RENESAS TECHNICAL UPDATE

Product Category	MPU&MCU		Document No.	TN-H8*-A406A/E	Rev.	1.00
Title	Correction of errors in the H8SX/1657 Group Hardware Manual		Information Category	Technical Notification		
Applicable Product	H8SX/1657 Group	Lot No.	Reference Document	H8SX/1657 Group Hardware Manual (REJ09B0341-0200)		
		All lots

(1) Page 308, the DTCER description in figure 8.1 Block Diagram of DTC

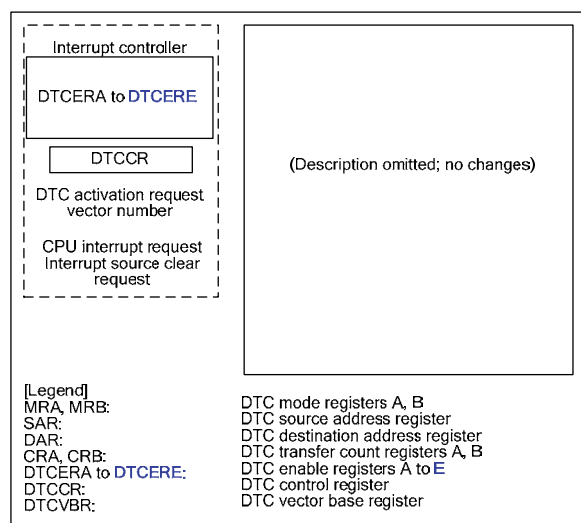
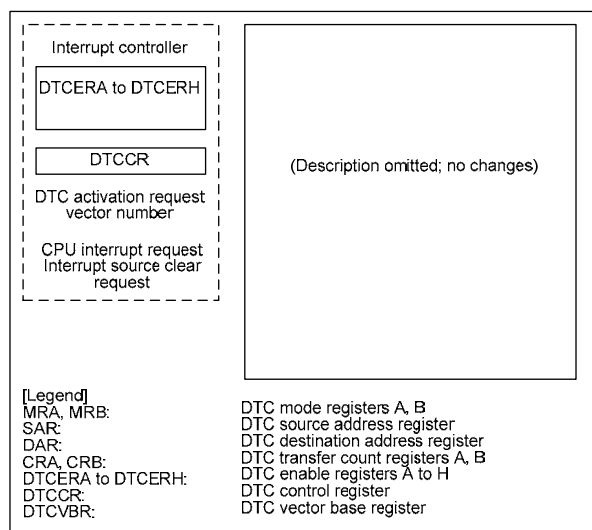
Deletion of DTCERF, DTCERG, and DTCERH
